**Subject: Response to Review Comments
Proposed Industrial Building
14940 Proctor Avenue
City of Industry, California**

Per your request, Leighton Consulting, Inc. (Leighton) presents our response to geotechnical review comments from the City of Industry's geotechnical reviewer (LOR Geotechnical Group, Inc.). This document serves as our response to the geotechnical review sheet, dated June 8, 2023, regarding our *Geotechnical Exploration Report* for the project (Leighton, 2021). A copy of the review sheet is attached in Appendix B. The comments are reproduced below in italics followed by our responses.

EXPLORATION LOCATION MAP
 Proposed Industrial Building
 14940 Proctor Avenue
 City of Industry, California

FIGURE 1

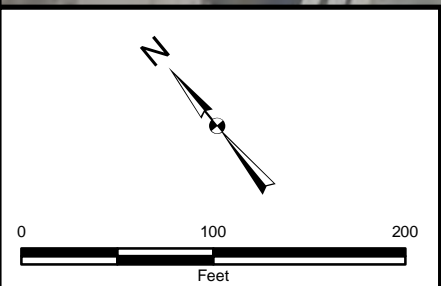
The report is older than 1 year. An update should be provided. The update report/letter should address the latest proposed development, the existing site conditions, and utilize the latest plans and/or tentative map as a basis for the geotechnical maps within the report. The update report/letter should address any changes to the proposed scope of work, the existing conditions, or geologic hazards. Additional soils data, updated analyses, and updated geotechnical maps may be required to provide adequate recommendations and conclusions. Design values and recommendations should utilize the currently adopted CBC (2022) and ASCE 7-16, including Supplement 3.

The currently proposed development plan for the project (RGA, 2023) is similar to the plan proposed at the time of our exploration. Based on review of RGA (2023), the proposed development includes demolition of the existing building and site improvements

to allow construction of a new one-story industrial building with a total building area of 165,537 square-feet. The proposed concrete tilt-up building will be constructed at grade with associated truck loading and surface parking. Ancillary improvements consist of utility infrastructure, pavement, flatwork, and landscaping. The currently proposed development plan has been overlain onto our *Exploration Location Map* (Figure 1) included with this response.
